ONE SYDNEY HARBOUR

STAGE 1B - Building R4B

SECTION 4.55

ARCHITECTURAL DRAWINGS

R4B ELEVATION SOUTH-EAST (LIFT LOBBY)

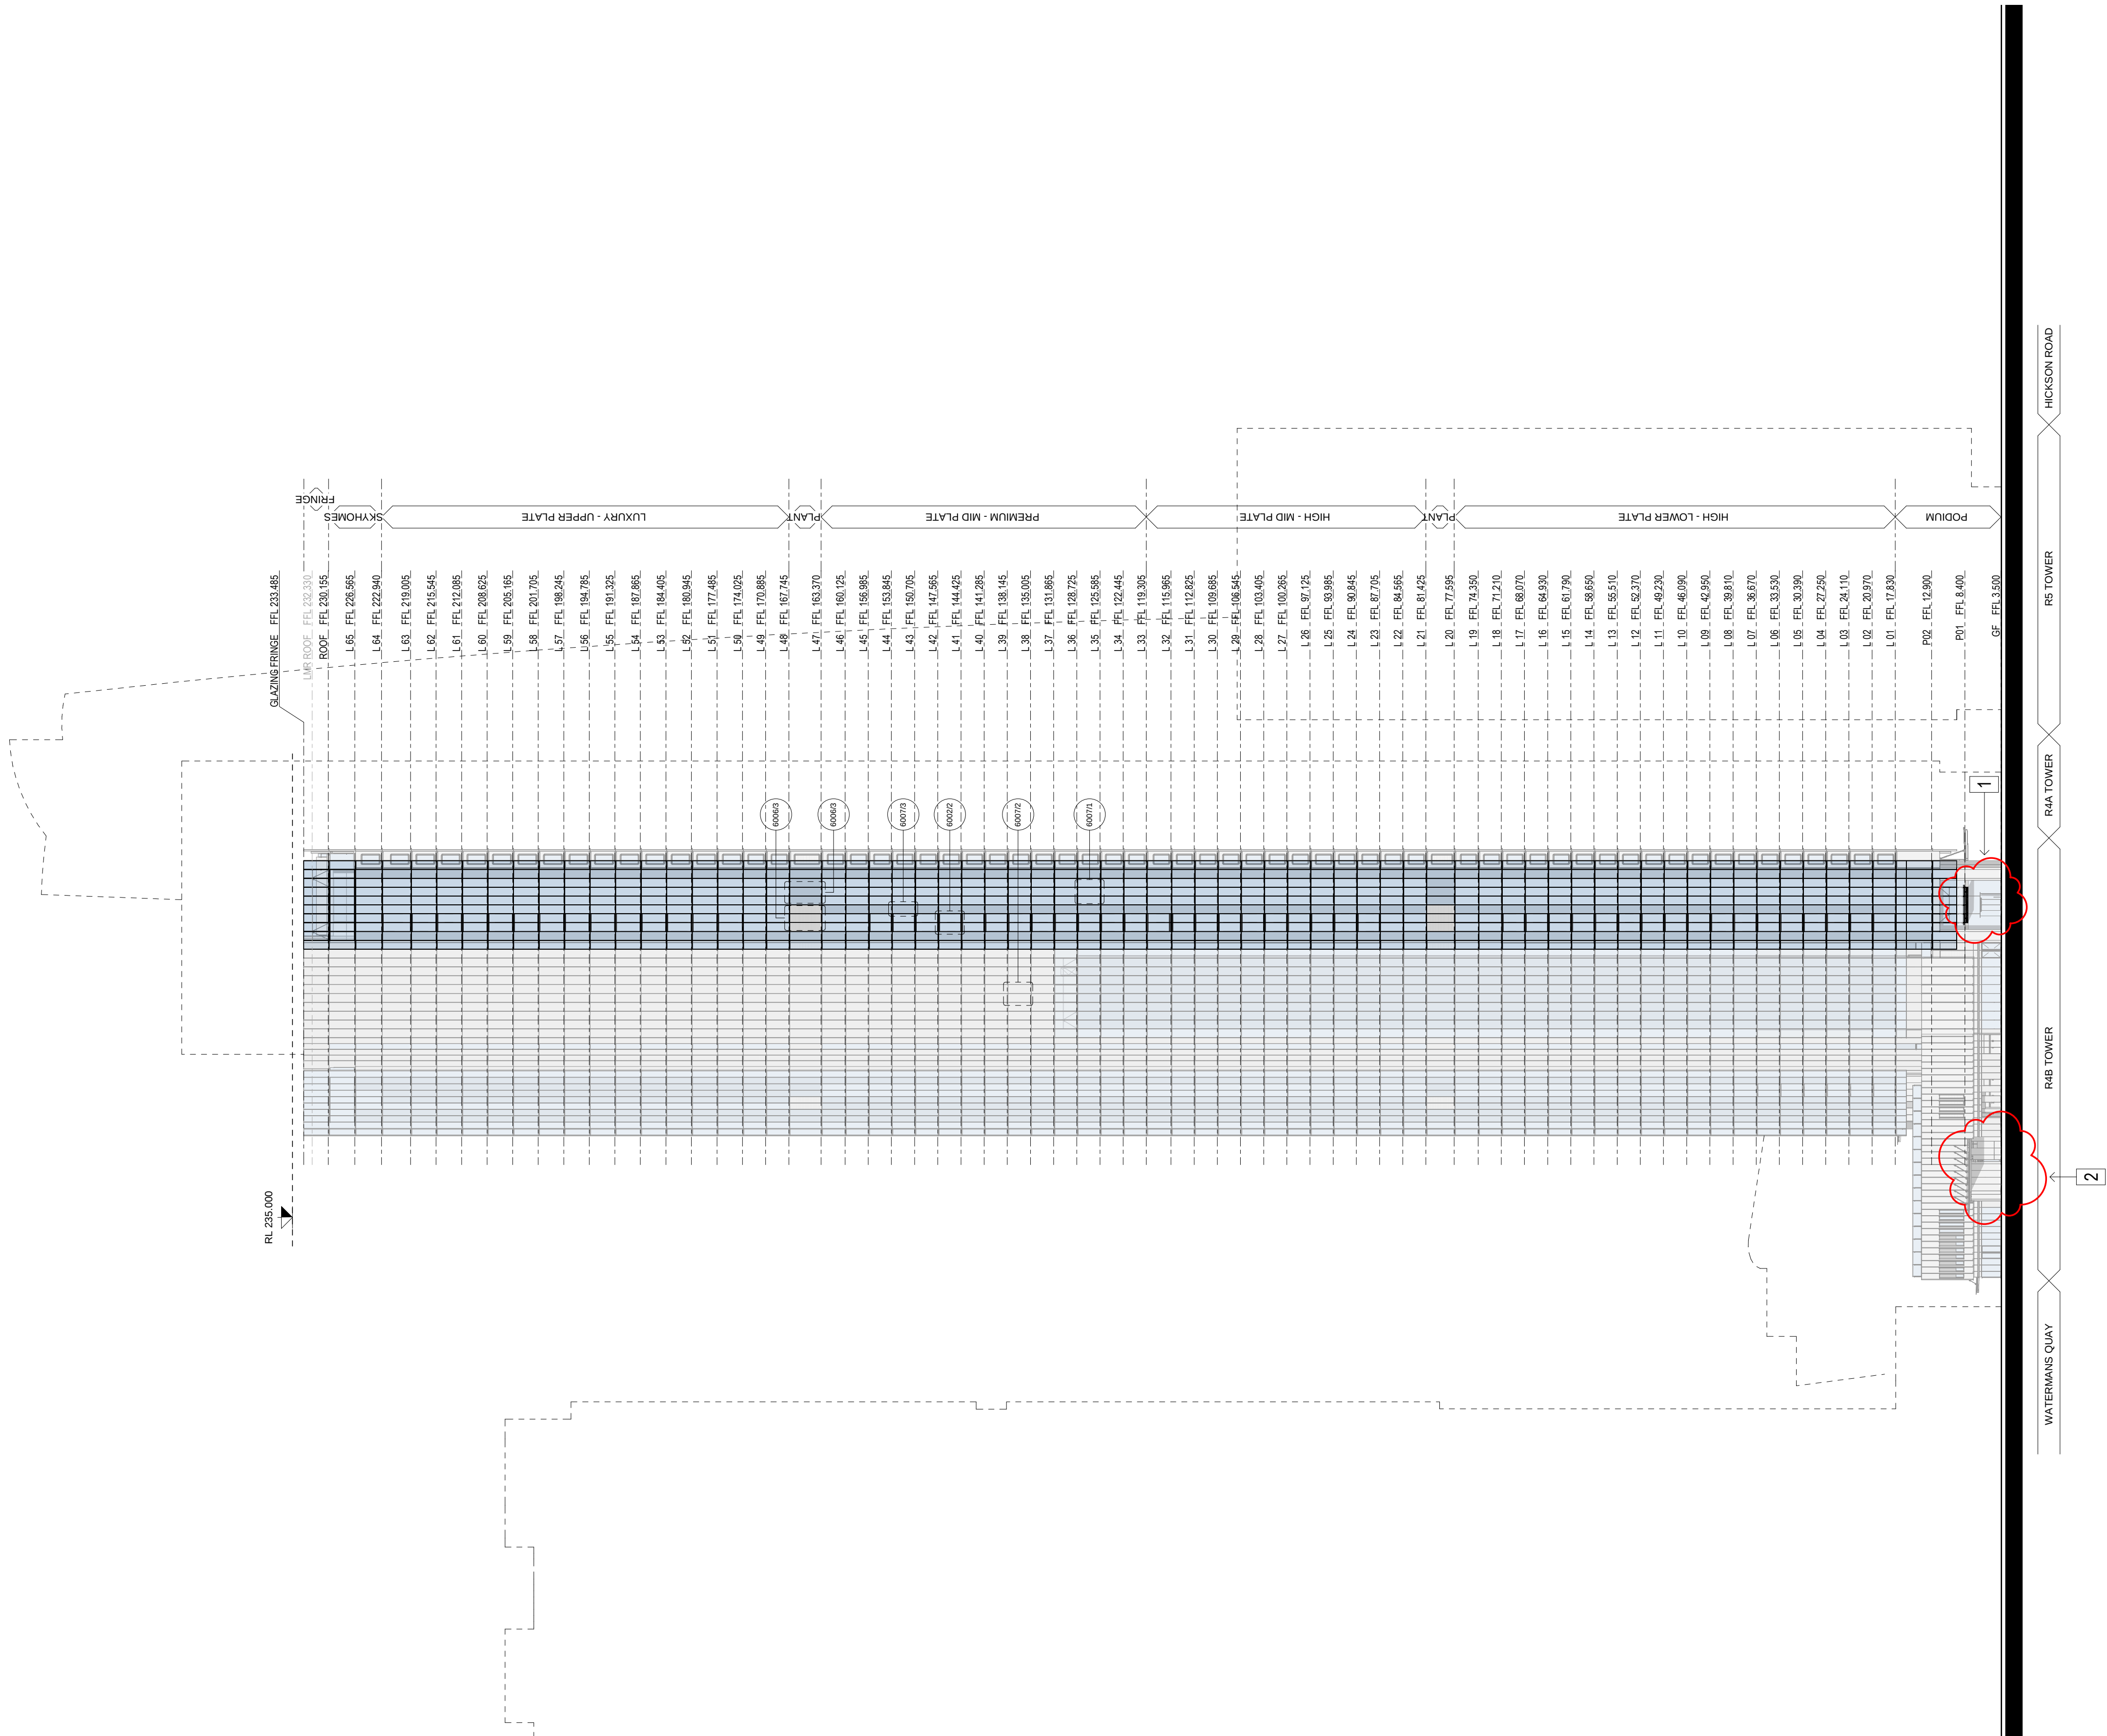
1. UPDATED ENTRY VESTIBULE DESIGN
2. UPDATED CARPARK ENTRANCE
3. REVISED SIGNAGE ZONE (SEE SUPPLEMENTARY DESIGN STATEMENT FOR FURTHER DETAILS)

R4B ELEVATION SOUTH (WATERMANS QUAY)

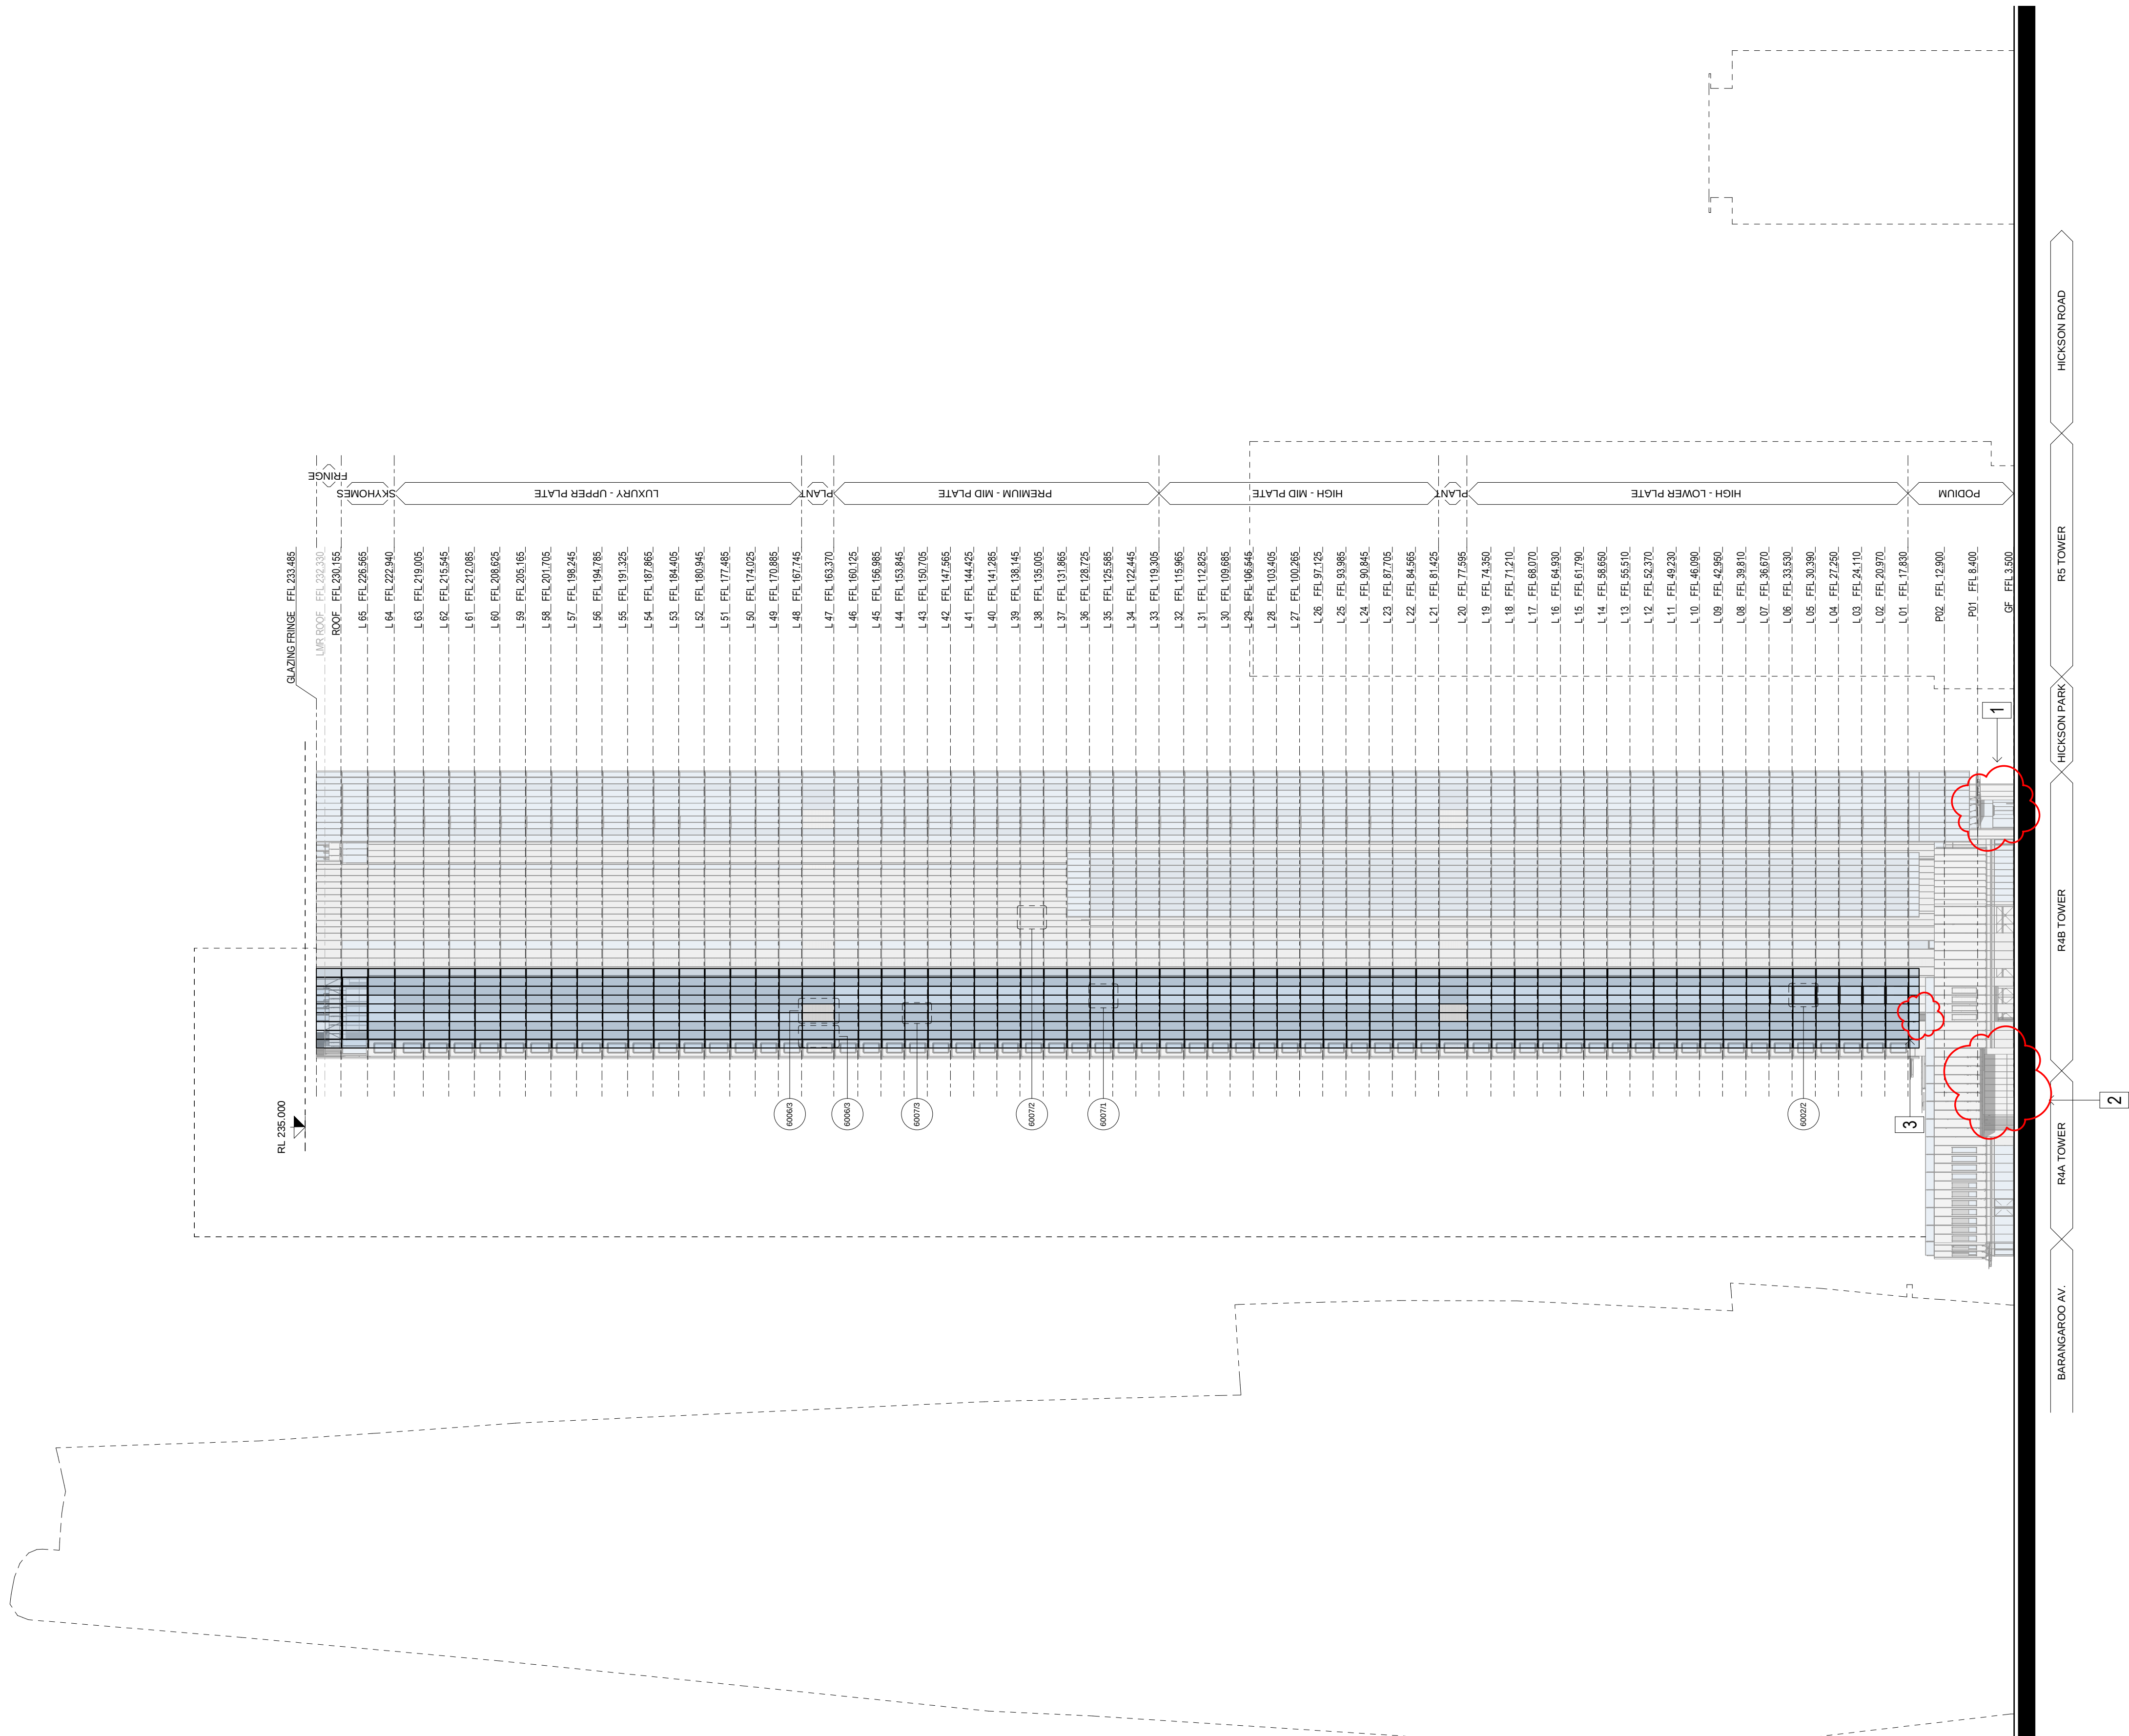
1. UPDATED ENTRY VESTIBULE DESIGN
2. UPDATED CARPARK ENTRANCE

Drawing: BR4B _ASD_PA2_4004
Date: 18 JUN 2021 Revision: 2
SECTION 4.55

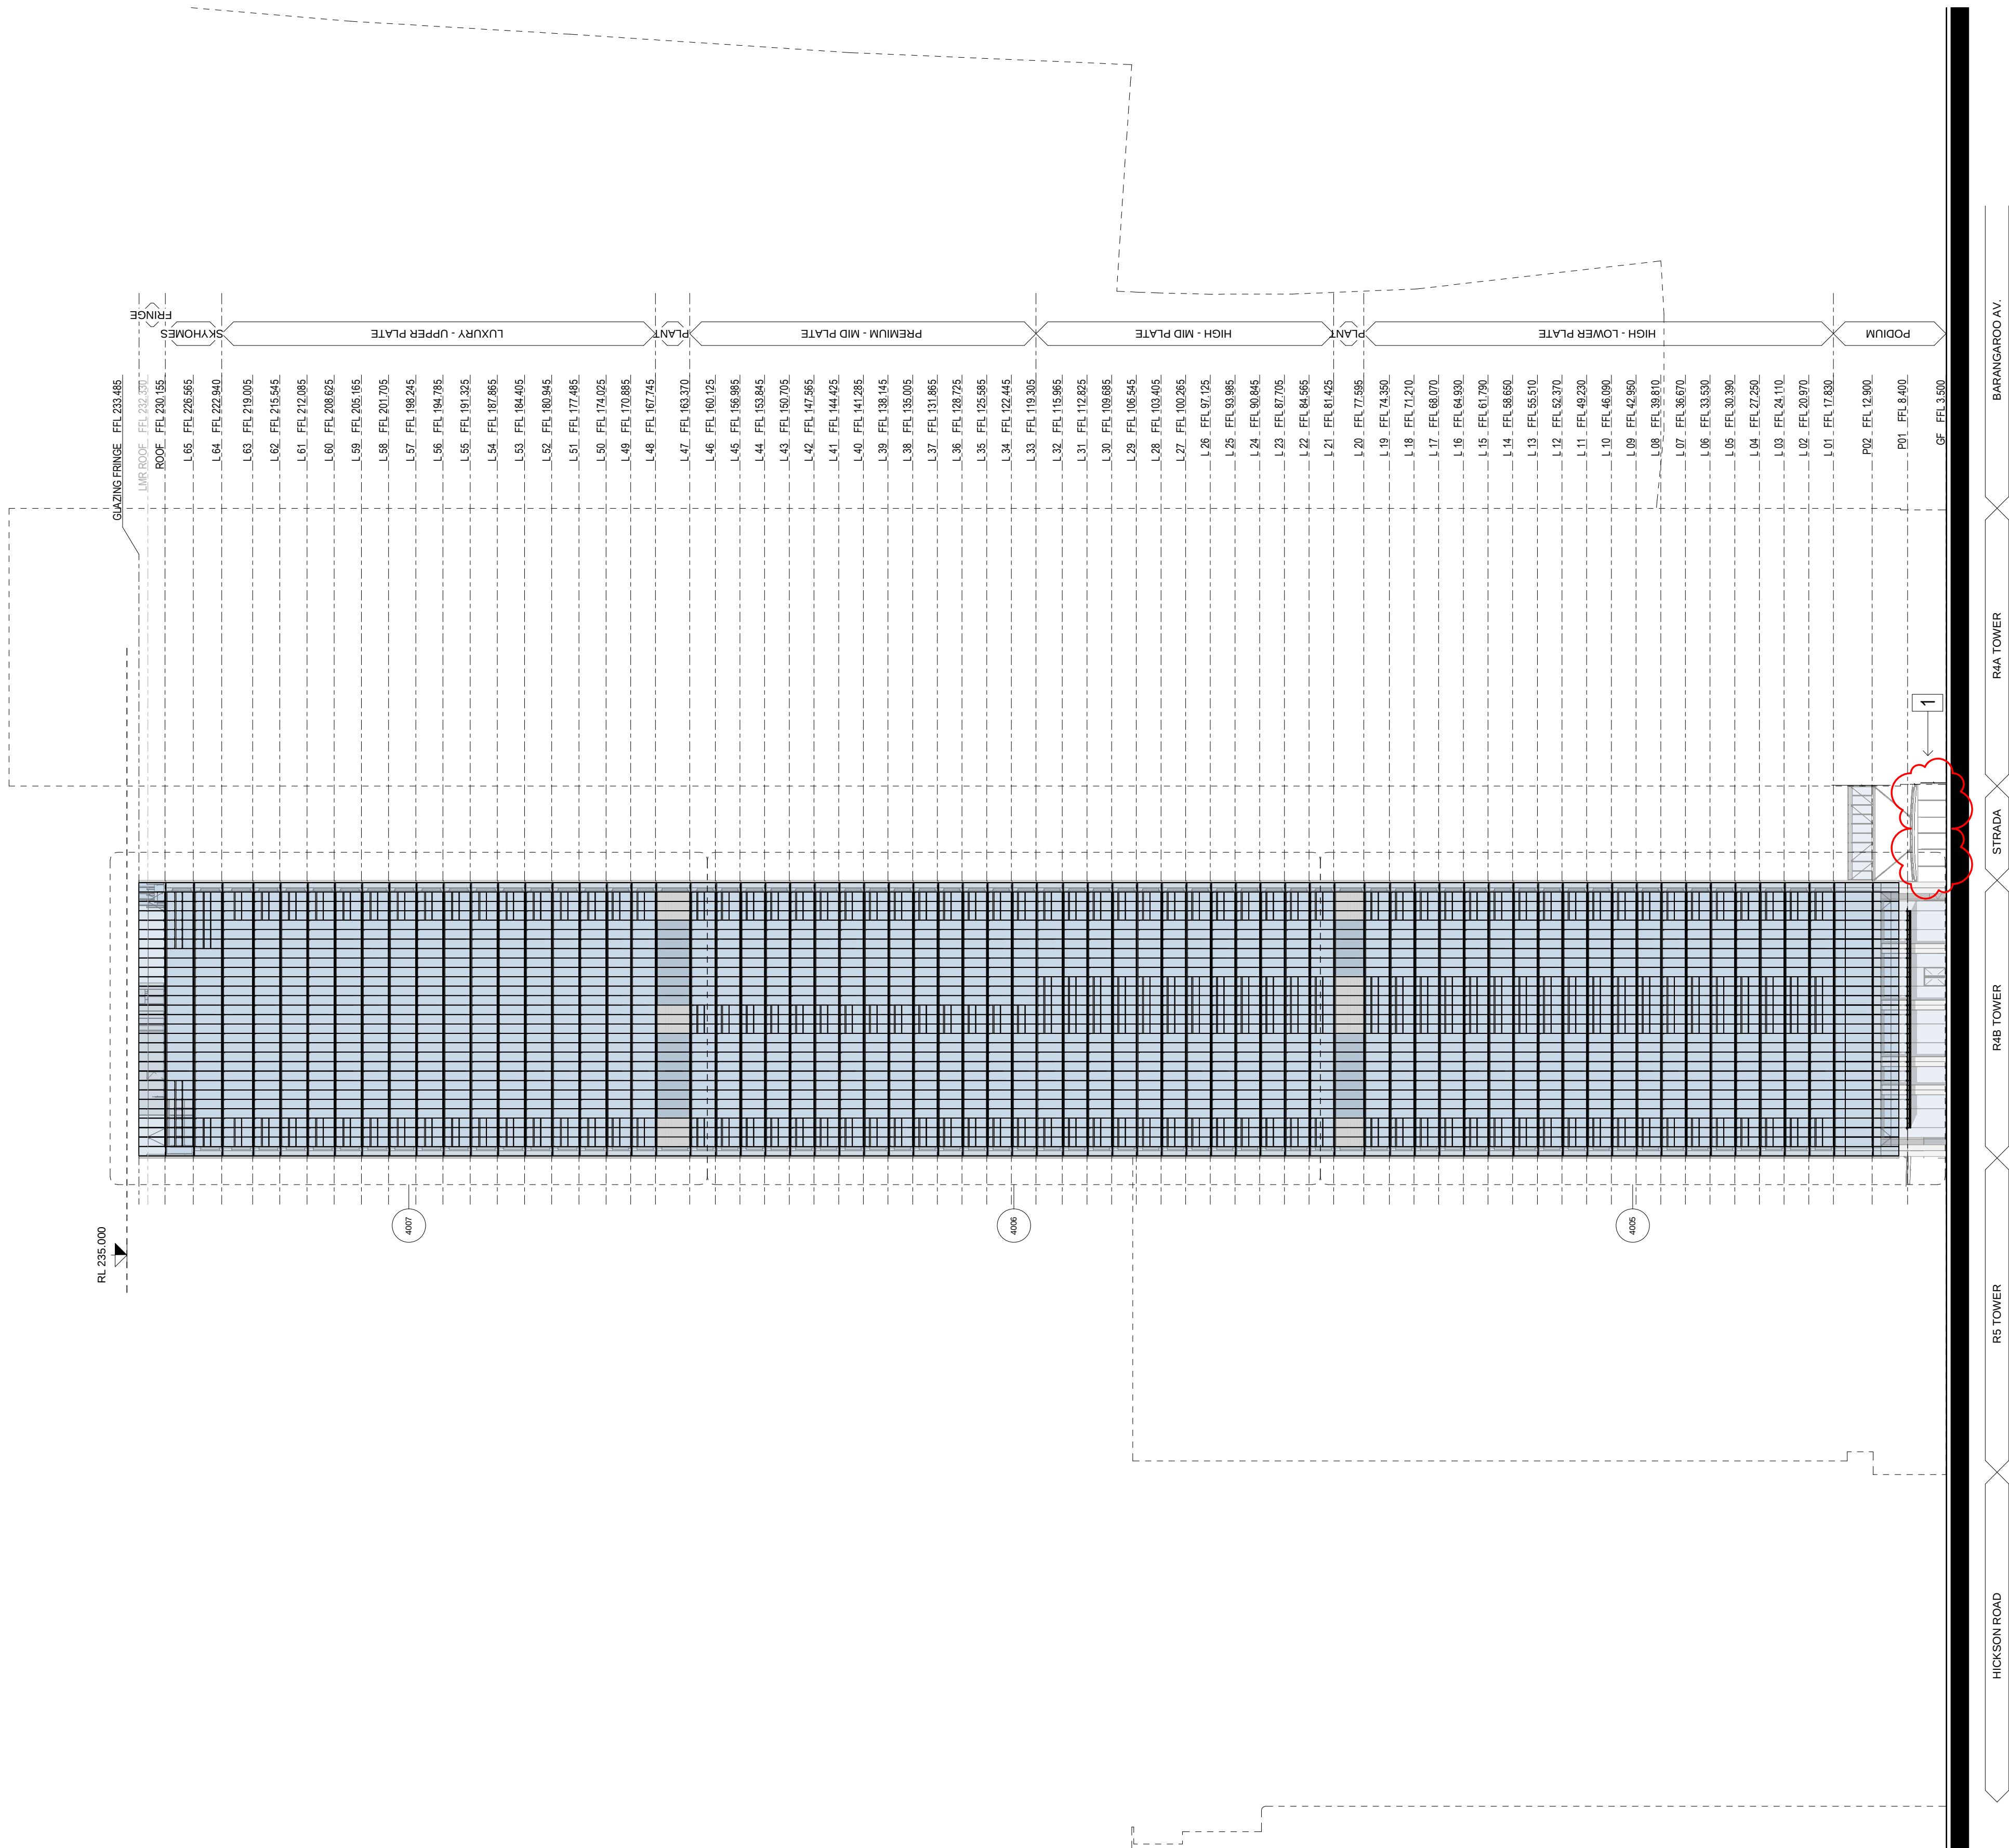
- MODIFICATION:
1. UPDATED ENTRY VESTIBULE DESIGN
 2. UPDATED CARPARK ENTRANCE
 3. UPDATED SKIRT DESIGN AND PORTAL DIMENSION
